SERVICE BULLETIN

APPLICABILITY: 2013MY Outback Models

NUMBER: 12-159-13

SUBJECT: Outside Odors Entering the Vehicle Interior

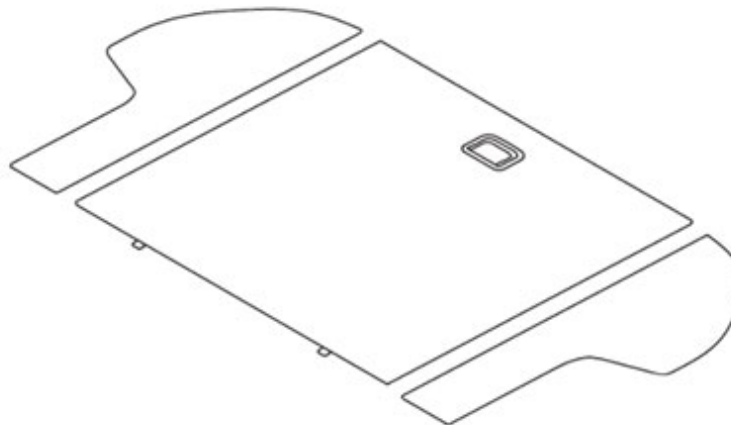
Should you receive a customer concern of outside odors getting inside the vehicle, this bulletin provides a repair procedure to address a possible entry point. Packing material has been added to the center retaining clips for the rear floor spacer and the keyless access / Push Button Start center antenna.

COUNTERMEASURE IN PRODUCTION

| CHANGE | STARTING VIN | PRODUCTION CHANGE DATE |
| New Floor Spacer Clip | D3283226 | February 1, 2013 |
| New Antenna Clip | D3299160 | March 2, 2013 |

NOTE: The new antenna clip is not available separately from the antenna assembly.

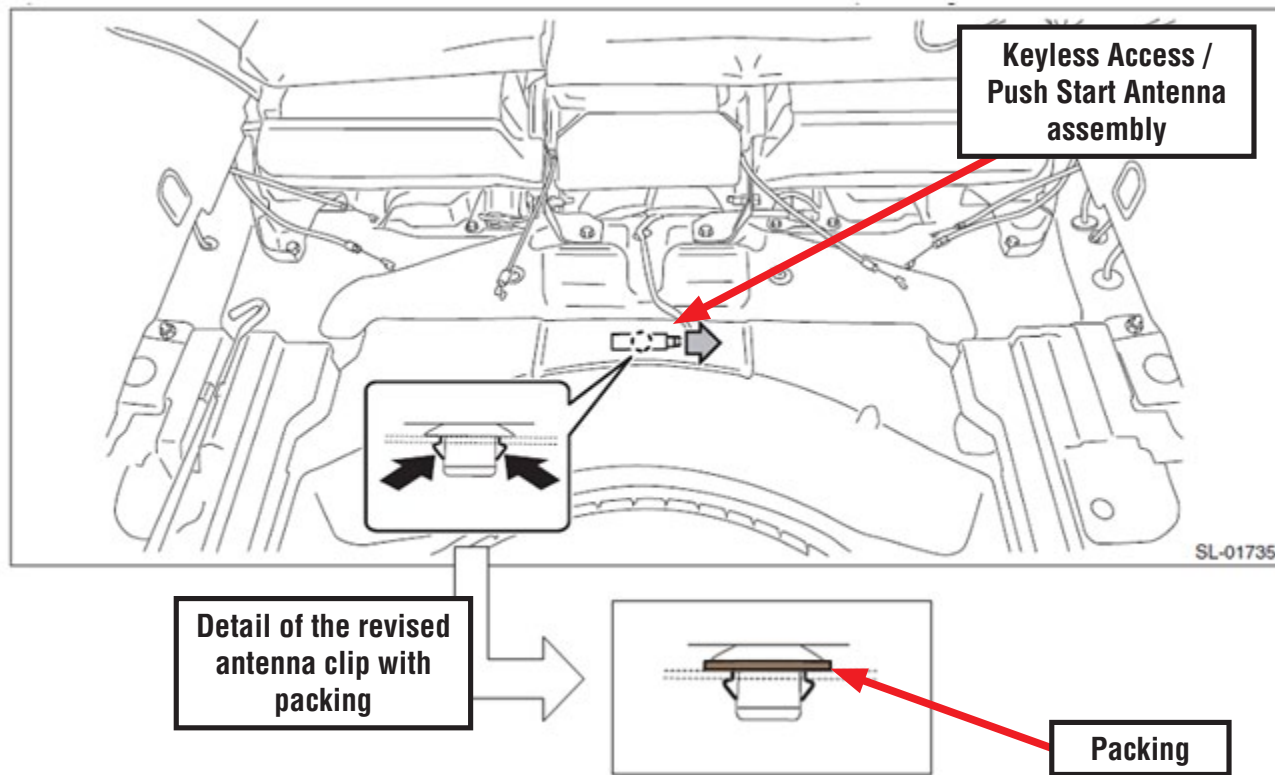
- If the vehicle **is not** equipped with Keyless Access / Push Start, the only repair is to install the revised rear floor spacer retaining clip as shown in the illustration below. Always use the proper trim clip removal tool to avoid damaging the clips and/or the spacer.

- If the vehicle **is equipped** with Keyless Access / Push Start, carefully remove the 3 retaining clips then the rear floor spacer to access the center antenna assembly. Replace the antenna assembly (which also includes a revised retaining clip) following the procedure in the applicable Service Manual. Torque the antenna bracket retaining bolt to 7.5 Nm (5.5 ft. lbs.). Make sure to use the new style retaining clip as shown in the illustration above when installing the floor spacer.
